# Service Bulletin

Bulletin No.: 15-08-51-001B

**Subject:** Availability of Insulator Service Part for Prevention of Liftgate Rust/Corrosion at Center Applique

**Models:** 2010-2015 Chevrolet Equinox  
2010-2015 GMC Terrain

4252404

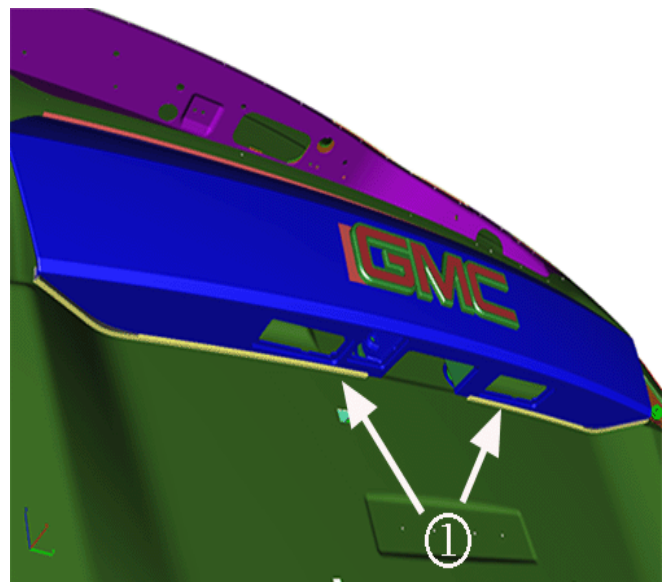
On some vehicles, due to the applique contacting and rubbing on the liftgate painted surface, rust spots (shown circled above) may be evident at the lower corners of the center chrome applique on the rear liftgate.

When repairing this rust spot condition, it will be necessary to remove the original applique, and repair any rust spot condition following common industry standards. Then, depending on model being repaired, follow the appropriate service part replacement advised below:

4252408

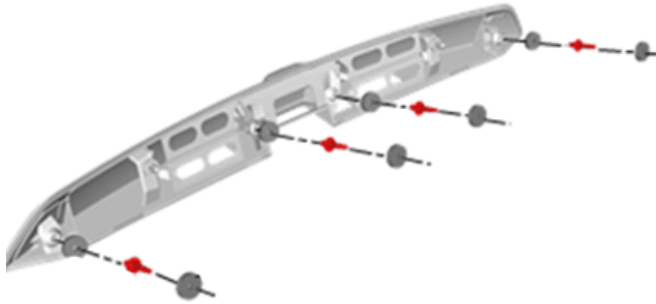
- **For Terrain models**, a two piece insulator is available as a service part, separate from the applique assembly. After repairing the rust condition, the new insulator parts (1) should be installed between the original applique and the liftgate. Refer to *Rear Closure Center Applique Insulator Replacement (GMC)* in SI.
